Work Order ID 140852

Item Name: Lower Cutter Assy

APICAL
INDUSTRIES, INC.

ENGINEERING CHANGE NOTICE NO.		02195		SHEET 1 OF 4	
DWG NO.	646.3000	REV: N/C	PREPARED BY	S. HUFF	DATE: 01/05/09
DWG TITLE:		LOWER CUTTER ASSY			
APPROVED BY:	ENGR <i>[Signature]</i>	MFG	<i>[Signature]</i>	QC	<i>[Signature]</i>
TRANSACTION CODES (TC): A-ADD C-CREATE R-REVISE D-DELETE		REASON: REMOVED RIVETS IN FAVOR OF ADDITIONAL SCREWS			
		EFF:		NEXT ORDER

SHEET 1, ZONE D5, IS:

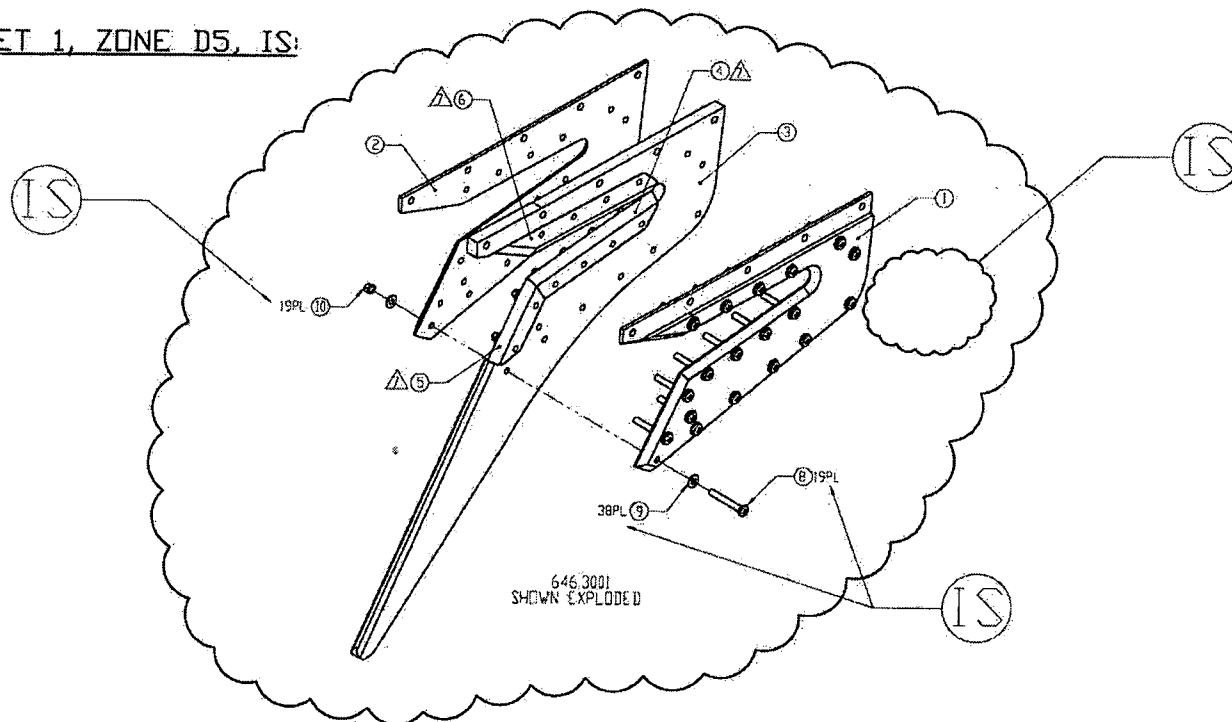
10	R	601.1541	19	LOCKNUT	MS21042L08
9	R	601.2764	38	WASHER	NAS1149FN832P
8	R	601.2765	19	SCREW	MS27039-0819
7	D	601.2766	2	RIVET	MS20470AD5-18
			.3001		
F/N	TC	PART NUMBER	QTY	DESCRIPTION	MATERIAL/SPECIFICATION
DOCUMENTS EFFECTED:				☐ MDL ☒ INSTALL INSTRUC ☒ ICA ☐ FMS ☒ BOM	CHANGE CATEGORY ☐ MAJOR ☒ MINOR
				DER REVIEW REQUIRED ☐ YES ☒ NO
